Subject: Minutes of the February 21, 2008 MAGNASTOR Draft RAI Part II Teleconference
Docket No. 72-1031 (TAC No. L23764)

Draft RAI-Part II Teleconference
Docket No. 72-1031, (TAC No. L23764)
March 14, 2008

**MAGNASTOR Draft RAIs
NRC Teleconference February 21, 2008**

Figure 5.1-1 YAEC-1937 versus NAC Burnup Profile for 30-35 GWd/MTU PWR Fuel Assemblies

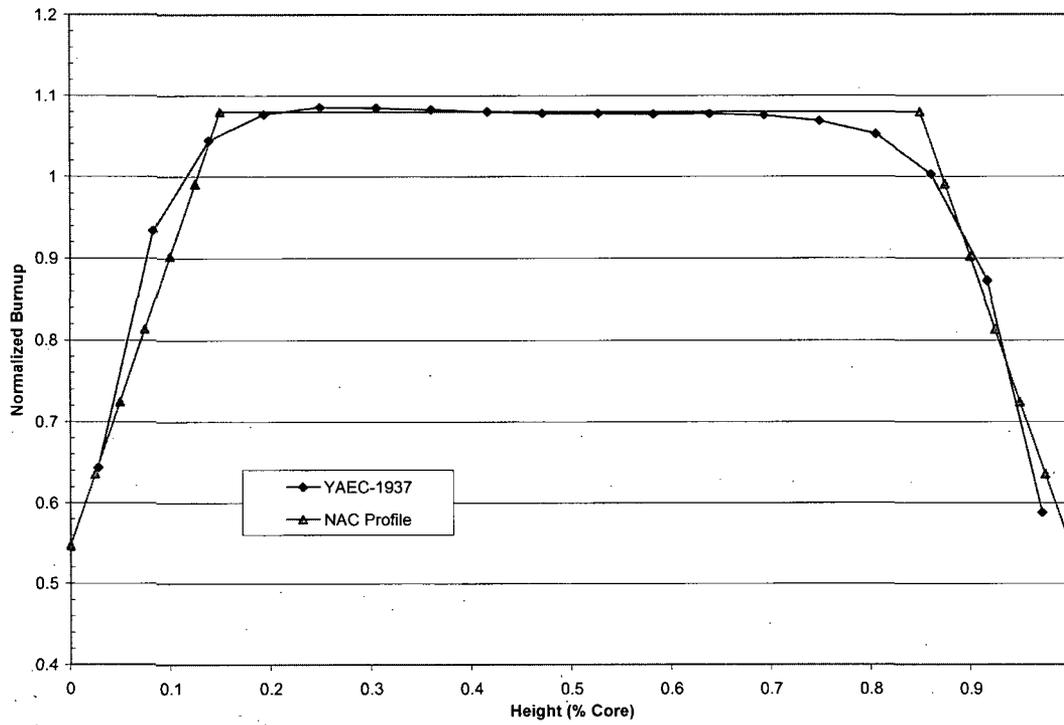
Provide information and justification on and the source term evaluation results of the fuel assemblies that contain axial end unenriched uranium blankets.

The applicant provides in Chapter 1 of this SAR a general description of the MAGNASTOR. In Sections 1.4 and 2.2, the SAR states that allowable contents include fuel assemblies containing natural uranium axial blankets. The staff, however, was unable to find from the SAR any further information on this type of fuel assemblies and corresponding shielding evaluations with these contents.

The SAR terminology section in Section 1 and definitions in Section 13 will be modified to specify the definition of assembly initial enrichment. Assembly average enrichment and average burnup definitions will include specific references to axial blankets. Text is added in Section 5.3 to clarify the origin and applicability of the burnup curves to blanketed fuel. Also included in Section 5.3 of the SAR will be the RAI response Figure 5.1-1. Both text and figure are included in the RAI 5-8 "Draft SAR Text Change" section.

Value calculated by averaging the ^{235}U wt % enrichment over the entire fuel region (UO_2) of an individual fuel assembly – including axial blankets if present.

Value calculated by averaging the burnup over the entire fuel region (UO_2) of an individual fuel assembly – *including axial blankets if present.*

Figure 5.3-3 Average and Midplane Storage Cask Dose Rates as a Function of Burnup (Fixed Heat Load - 4 Year Minimum Cool Time)

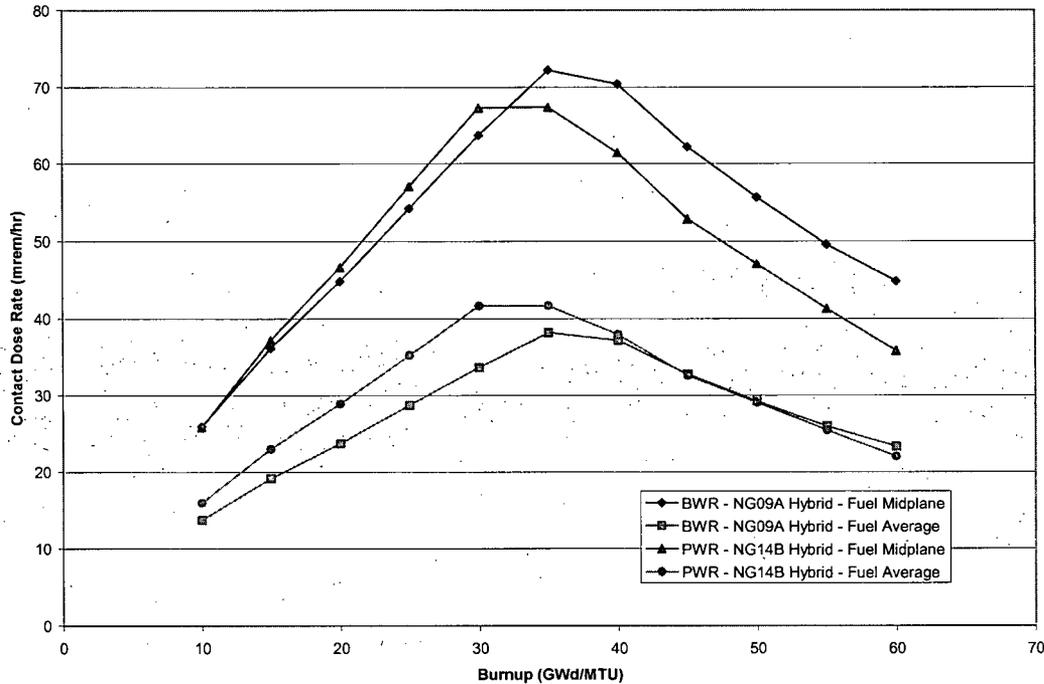
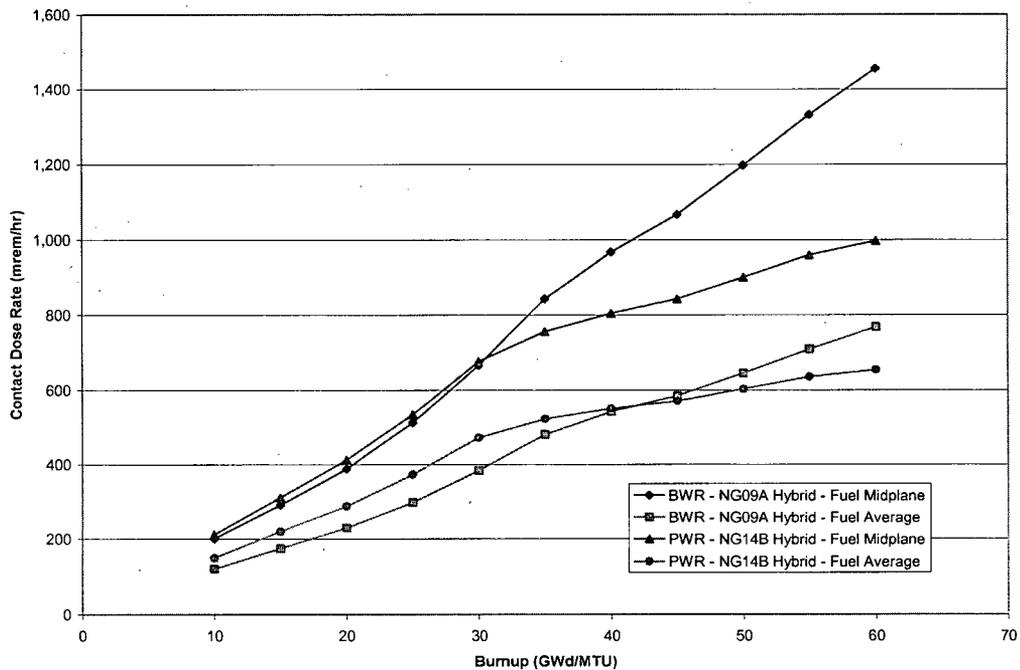
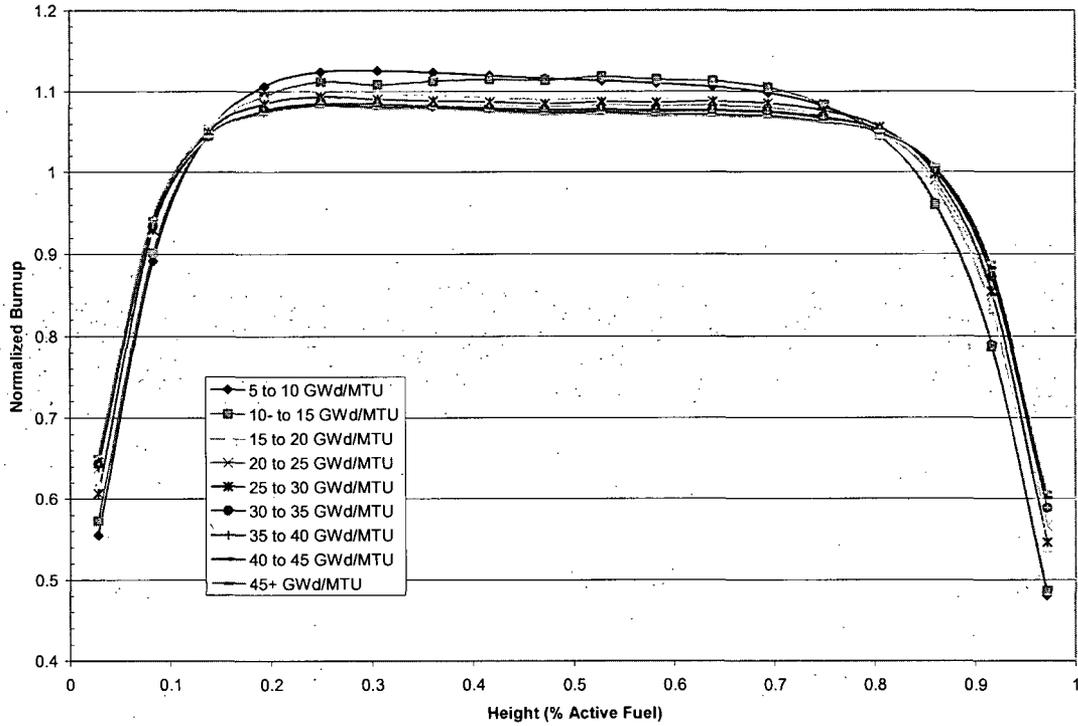
Section 5.3 of the SAR states that an axial uniform peaking factor is used in calculating the source term. The peaking factors are 1.08 for PWR assemblies based on calculated data from Seabrook and Yankee plants and measured Turkey Point gamma data. The peaking factor is 1.22 for BWR assemblies based on calculated data from Washington Public Power BWR/4-6. Studies in NUREG/CR-6801, which used a much broader spent fuel assembly database, indicate larger peaking factors and more complex burnup profiles for low burnup fuels.

As discussed in the response to draft RAI 5-8, lower burnup fuel assemblies, while displaying larger peaking factors than those obtained from >30 GWd/MTU fuel assemblies, produce significantly lower dose rates (at a fixed profile). The dose decrease is significantly larger than the peaking factor increase. Note that site dose rates (10 CFR 72.104 limit on storage systems) is driven by system gamma dose rates which are proportional to the average fuel source which decreases by 15% going from 30 GWd/MTU to 25 GWd/MTU and by over 30% shifting from 30 GWd/MTU to 20 GWd/MTU.

The SAR text in Section 5.3 is revised to identify the justification for the statement. The statement is rewritten to clarify that higher burnup fuels produce bounding dose rates and include supporting justification in terms of the dose rate plots provided in the technical discussion.

Figure 5.3-6 contains YAEC (YAEC-1937, RSICC Document DLC-201) compiled PWR burnup profiles at 5 GWd/MTU increments showing low burnup fuel having a higher peak. Peaking is less than 10% higher for the low burnup material, which is a smaller increase than the dose decreases plotted in Figure 5.3-3 and Figure 5.3-4 for the lower burnup fuels. The following discussion therefore describes the burnup profile for fuel burned in excess of 30 GWd/MTU. The 30 GWd/MTU derived profile is applied in the shielding evaluations summarized in Sections 5.1 and 5.6 and detailed in Section 5.8.

Fuel burned in excess of 30 GWd/MTU produces the maximum dose rates as shown in Section 5.6. For PWR fuel, an enveloping axial burnup profile with a 1.08 uniform peaking factor is justified on the basis of calculated PWR data from Seabrook Station and Maine Yankee and from measured Turkey Point gamma data [13,14,15,16,17]. This normalized enveloping shape is shown in Figure 5.3-1. A uniform burnup peaking factor of 1.08 is applied between 15% and 85% of core height. Above and below these elevations, the relative burnup/decay heat decreases linearly to 0.547 at the top and bottom of the active fuel region.

Figure 5.5-7 NAC-CASC "Black Body" Assumption Test along Short (X-Axis) Side of Array

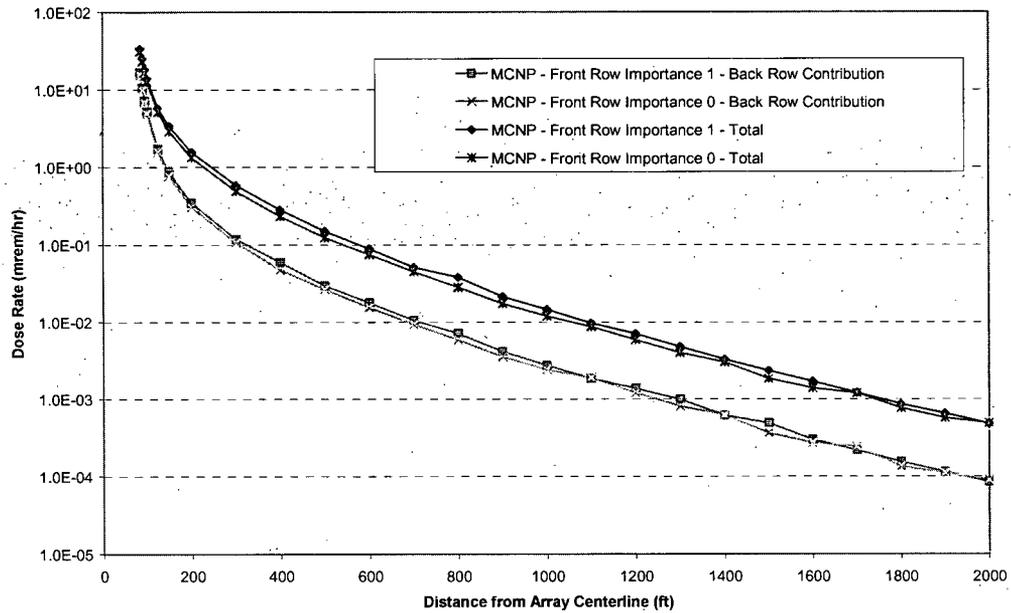
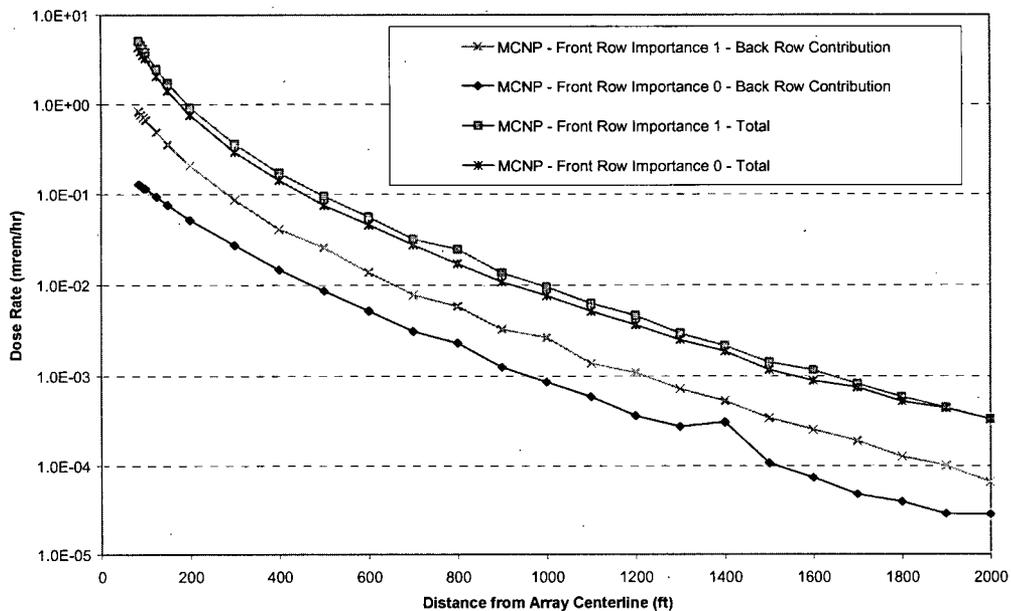
- (e) Provide explicit definition of the term "cask self-shielding." Provide technical (including theoretical) basis for not tracking the particles that hit the cask between the source and the detector. Justify the assertion that the radiations emitted from the surface of one cask and subsequently hit an adjacent cask will not have a significant contribution to the site boundary dose rate because of the thickness of the cask concrete.

- f.) NAC agrees that radiation scatter from hard surfaces (such as the cask pad or surrounding surfaces) may play a significant role in the total dose rate around the ISFSI and the code only terminates tracks of particles directly intersecting adjacent casks. A typical cask array of 11.5 foot diameter casks does not provide a significant open area for radiation scatter from the radial surface of the "shadowed" cask to influence the off-site dose primarily dominated by the "front" row casks. Note that only particles originating from the cask radial surface have any potential to intersect casks within the skyshine array. To demonstrate that the assumption of terminating tracks does not have a significant effect on site boundary dose rates, MCNP evaluations were performed on a 2x10 cask array set with the evaluated source limited to the radial (cylindrical) surfaces of the back row of 10 casks. Dose rates are plotted in the following figure along the axis of the side facing the back row and front row of the array assuming the front row of casks are at a nominal importance (1) and at an importance of 0 (i.e., terminating the particle track). As shown in the figure, there is no significant effect of the assumption to terminate cask scattered particles.

- a.) The SAR is revised to include the technical discussion shown above.
- b.) As the manual is copyrighted material, NRC to obtain the relevant code manual and references.
- c.) The SAR is revised to correct the equations.
- d.) SAR changes are made in RAI 5-1, 5-7, and 5-8 to address profile concerns.
- e.) The SAR is revised to augment the discussions involved with particle track termination and to include the MCNP comparison to demonstrate the acceptability of the "terminate particle" assumption.

“NAC-CASC, a modified version of SKYSHINE-III, uses the MCNP generated cask surface current to estimate site boundary exposures. NAC-CASC allows for self-shielding of casks and permits input of an angular surface current emission spectrum. In the NAC-CASC evaluations, the concrete casks are modeled as “black” body cylinders. Given the concrete cask thickness, radiation emitted from one cask and impacting an adjacent cask will not significantly impact site boundary dose rates. *To verify the acceptability of this assumption, a radial neutron and gamma source MCNP analysis was performed on a 2x10 cask array with the front row assigned either an importance of 1 (same as back row casks) or assigned an importance of 0 (terminating the particle tracking). Results of this analysis are shown in Figure 5.5-7 for the short array axis (facing the x direction 2 cask side of the array in Figure 5.5-6) and Figure 5.5-8 for the long array axis (facing the y direction 10 cask side of the array in Figure 5.5-6). While significantly affecting the radial dose contribution from the “shielded” back row of casks along the y-axis, the “black body” assumption does not significantly affect total dose rates in this direction as the majority of dose is contributed by the front row of casks (i.e., casks facing the detector). Including the axial contribution in the comparison, which is not affected by the “black body” assumption, would further decrease the relative effect of the black body assumption.* The energy and angular spectrum of radiation emitted from the cask surface are retained when transitioning from the MCNP to the NAC-CASC model.

Figure 2-3 BWR Partial Length Fuel Rod Location Sketches

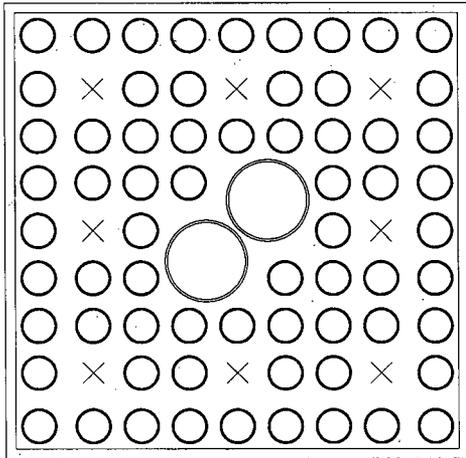
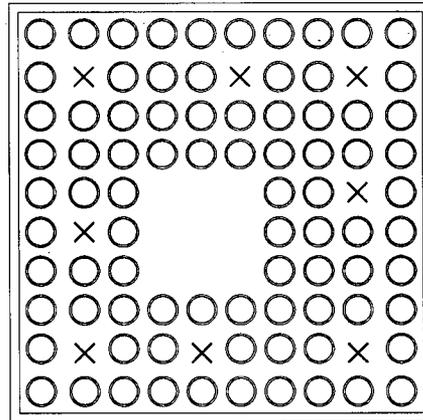
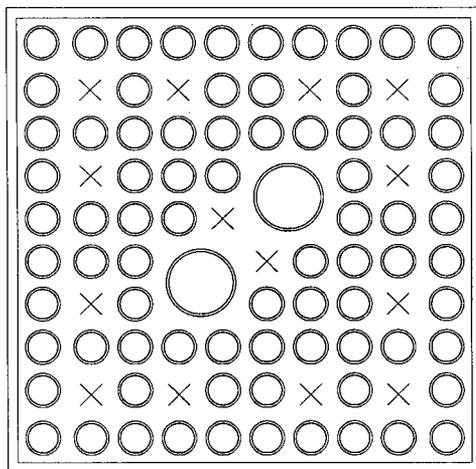
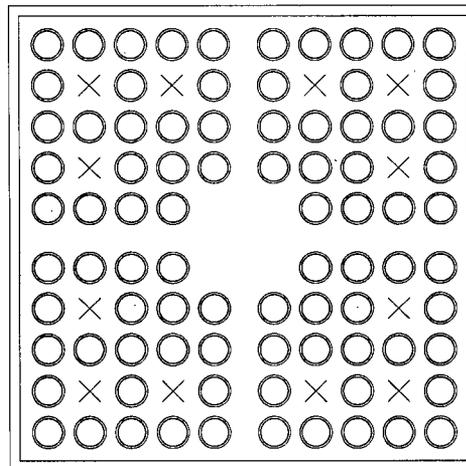
Revise Section 2.1.2 and remove Section 2.2 of the proposed technical specifications for Approved Contents to eliminate the authority to change fuel parameters in Appendix 1-A. Specify and justify which Appendix 1-A fuel parameters should be controlled in the FSAR, versus those that should be specified as an approved content in the CoC.

The staff is unable to approve this proposed change because NRC regulations in 10 CFR 72.244 prohibit a certificate holder from changing information contained in the CoC by any means other than an amendment to the CoC. Case specific alternatives to approved cask contents listed in the CoC may be submitted to the NRC review via the 10 CFR 72.7 exemption process. The staff recognizes that NUREG-1745, "Standard Format and Content for Technical Specifications for 10 CFR Part 72 Cask Certificate of Compliance" indicates that NRC believes this proposed approach and format is an acceptable means to assure the overall safety goals and removes unnecessary detail from the technical specifications. However, this format does not meet the requirement of 10 CFR 72.244. This information is need to demonstrate compliance with 10 CFR 72.236.

It is noted that NAC response to Draft RAI Part I, 13-4, has proposed the inclusion of the BWR partial length rod configuration in Appendix 1-A. It is recognized that different designs for BWR site specific assemblies may have different partial length rod array patterns and that these differences will not introduce significant impact on system criticality. Based on the known

If requested by NRC management, NAC will incorporate the information currently presented in Appendix 1-A into Technical Specification 13B Section 2.0, delete Appendix 1-A and revise Technical Specification 13A deleting reference to Appendix 1-A and Section 2.1.2.

1. Location of the partial length rods is illustrated in Figure 2-3.
2. Assemblies may contain partial-length fuel rods.
3. Assembly characteristics represent cold, unirradiated, nominal configurations.
4. Maximum channel thickness allowed is 120 mils (nominal).
5. Composed of four subchannel clusters.

Figure 3-1 TRANSFER CASK Surface Dose Rate Measurement

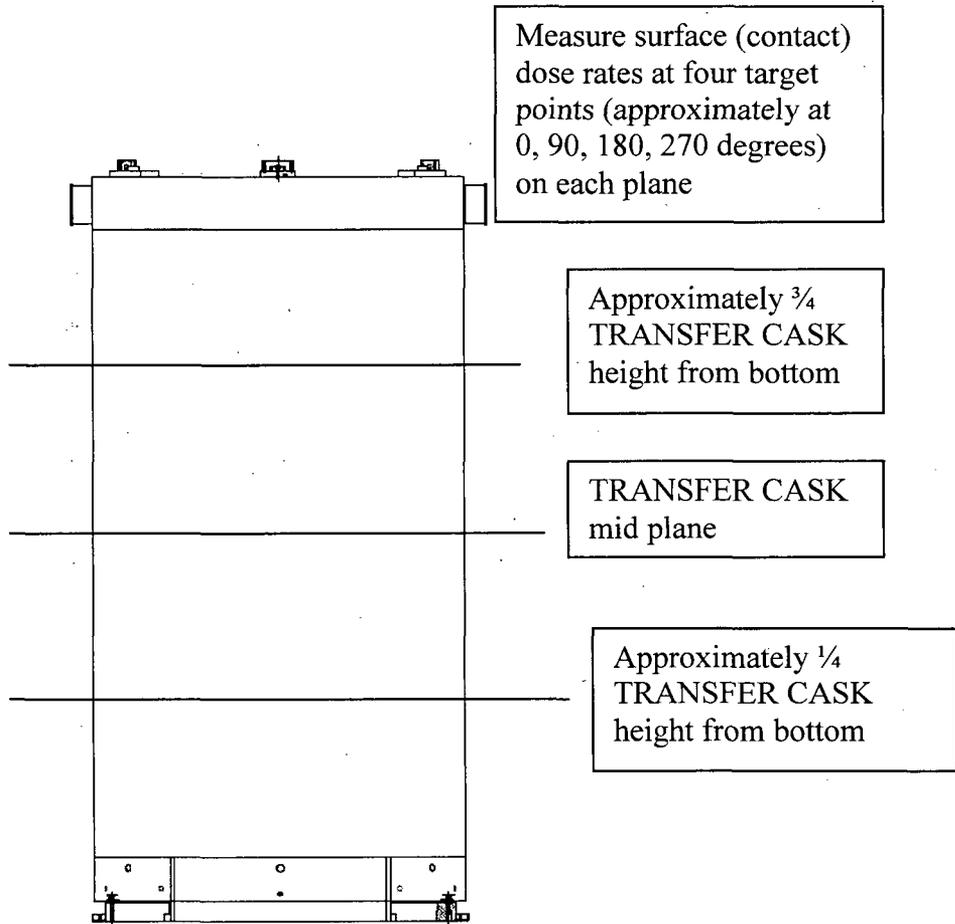
Add dose rate limits to the proposed technical specifications for the top and side of the transfer cask and the concrete storage cask.

The staff found after reviewing the dose rates and operating procedures that it is necessary to establish dose rate limits for the top and side of transfer cask and concrete storage cask. These dose rates serve several purposes. These dose rates (1) assist with gross mis-load detection and guiding ALARA planning and evaluations; (2) provide confidence that public dose limits will not be exceeded; (3) confirmation of the modeling results at the transfer cask surface gives confidence in the doses calculated at other distances; (4) confirms that the values used as the basis for the radiation protection analyses in the SAR and the site-specific Part 20 ALARA planning was appropriate; and (5) serves to maintain the shielding characteristics of the approved design without unduly restricting the changes that may be made under 10 CFR 72.48.

CONDITION	REQUIRED ACTION	COMPLETION TIME
A. TRANSFER CASK average vertical surface dose rate limits not met	A.1 Administratively verify correct fuel loading	24 hours
B. Required Action and Associated Completion Time not met.	B.1 Perform engineering assessment and establish safe configuration	60 days

SURVEILLANCE	FREQUENCY
SR 3.3.1.1 Verify average surface dose rates of TRANSFER CASK loaded with a dry CANISTER containing dry fuel assemblies are within LCO limits. Dose rates shall be measured at the locations shown in Figure 3-1.	During TRANSFER OPERATIONS
